Title Exciter Modulator & Quadrature Divider		
Size D	Number	Rev 0
Date	Drawn by PAlexander	
Filename	Sheet 5	of 7

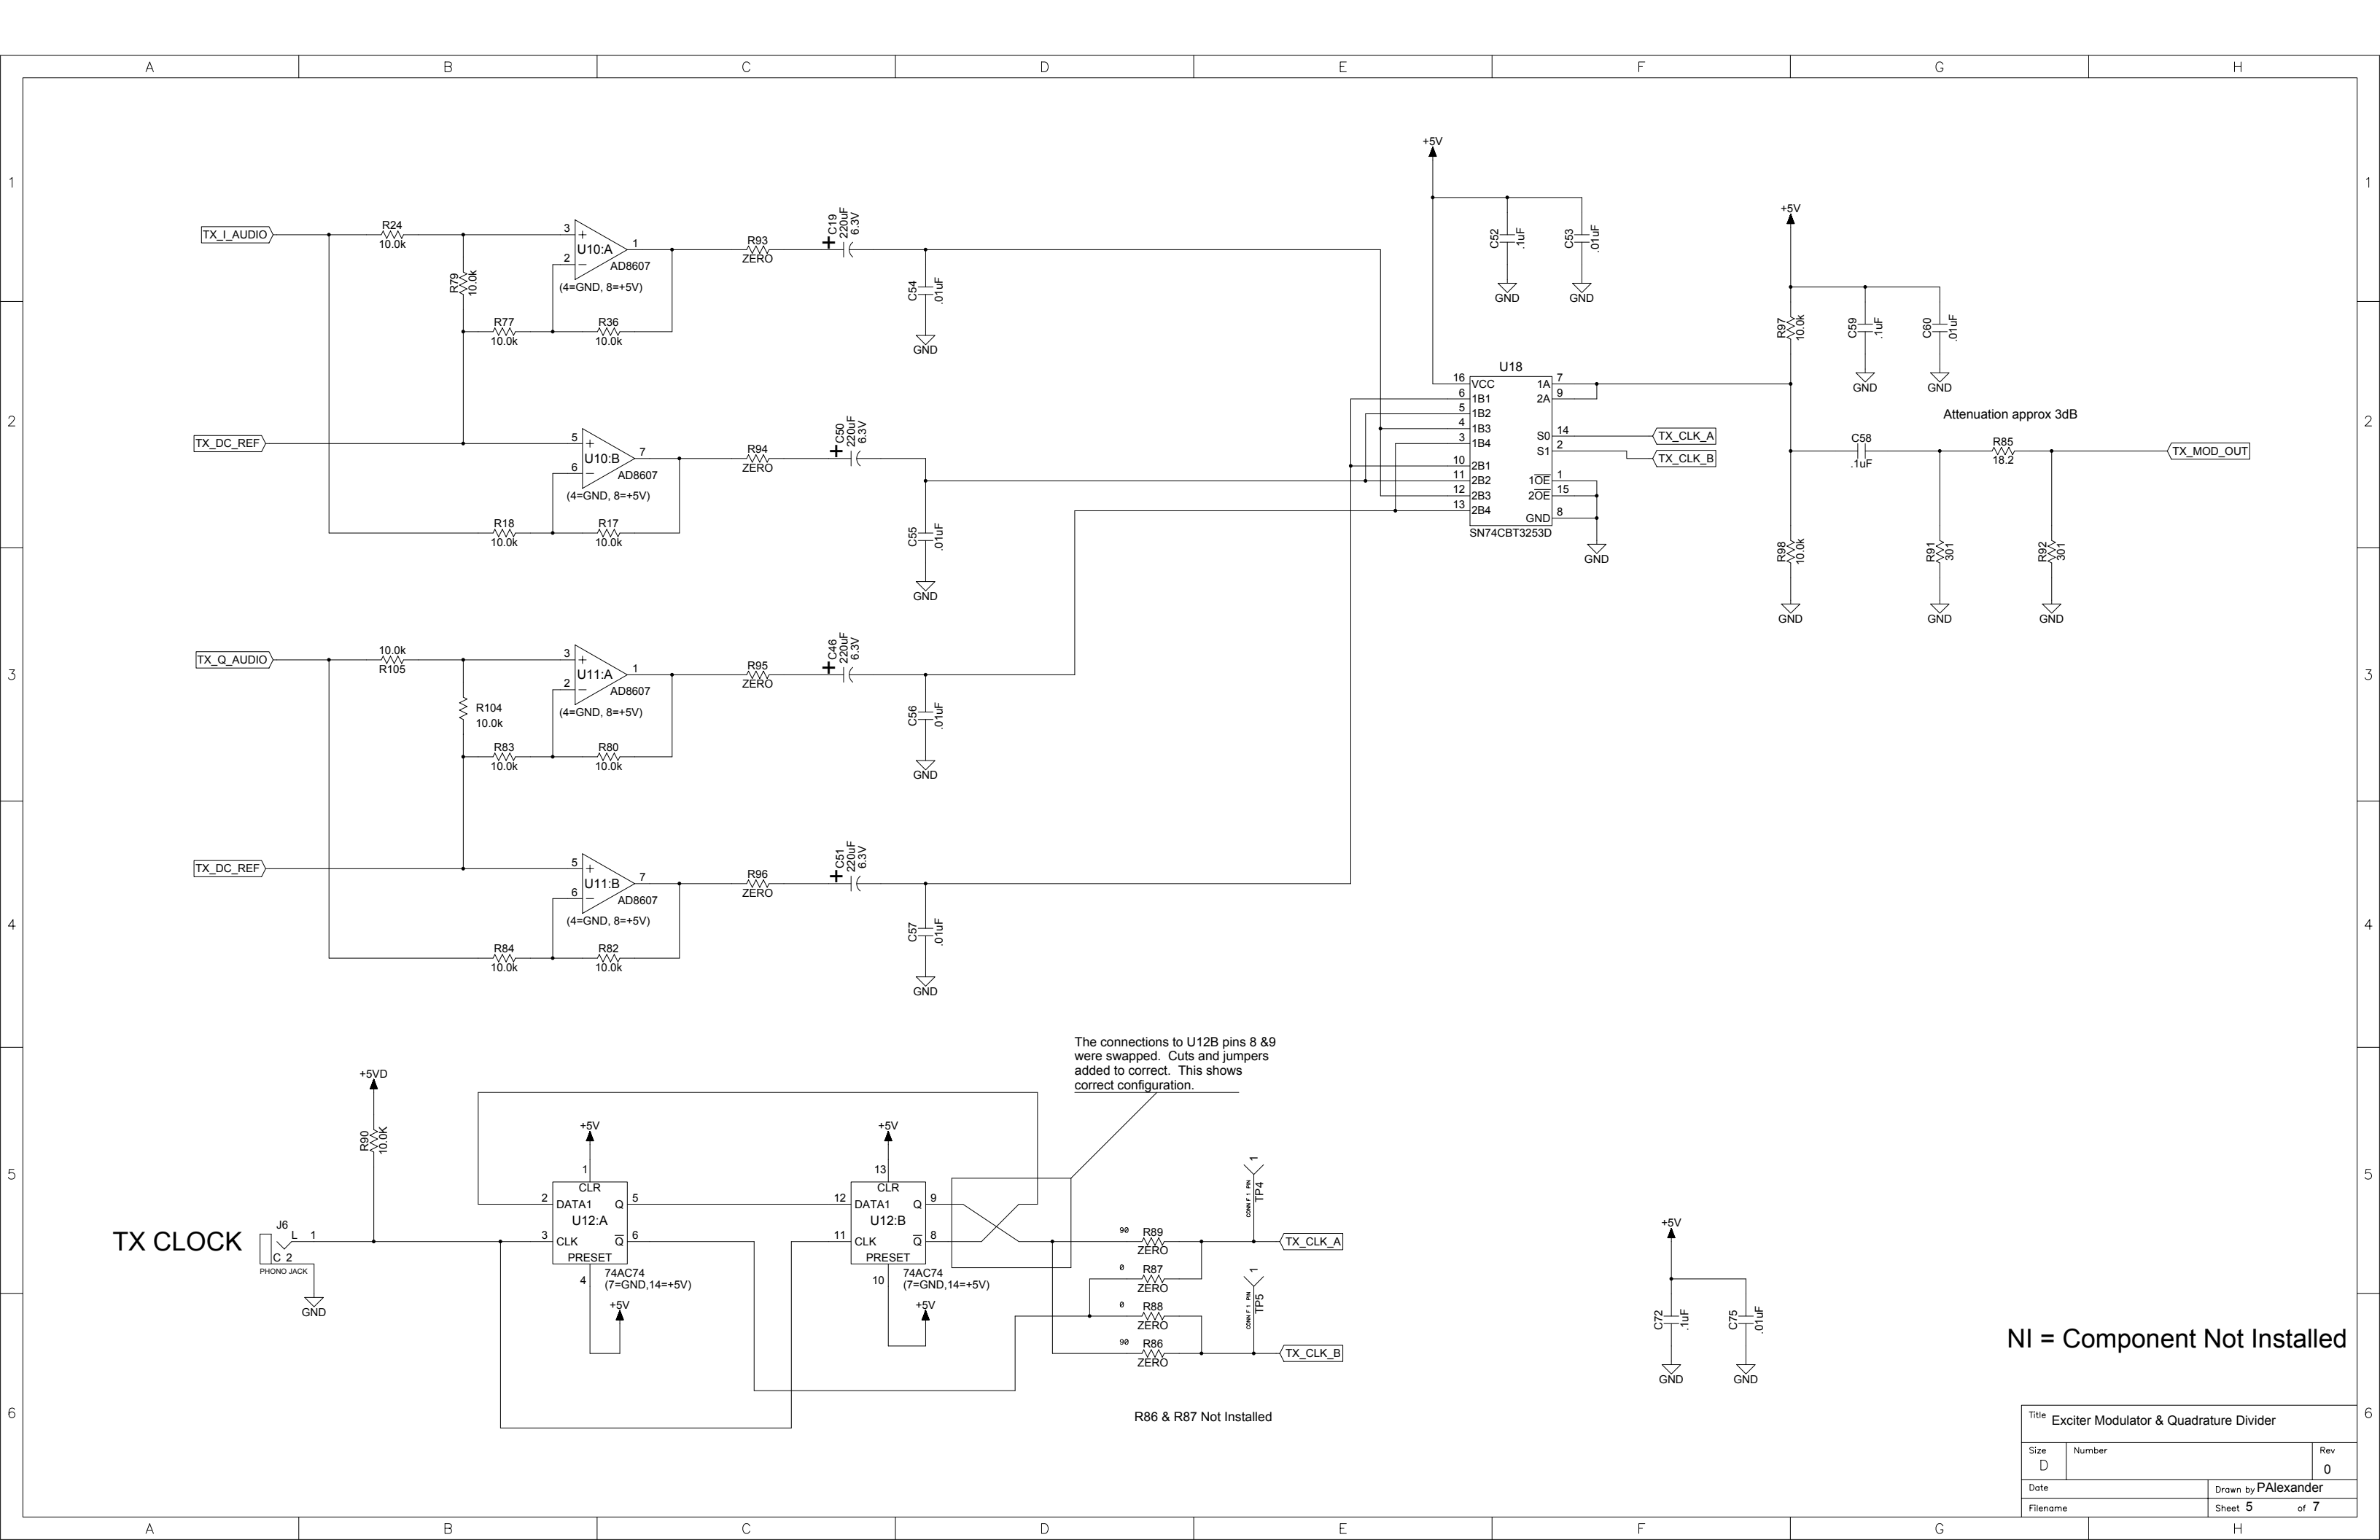
The connections to U12B pins 8 & 9 were swapped. Cuts and jumpers added to correct. This shows correct configuration.

R86 & R87 Not Installed
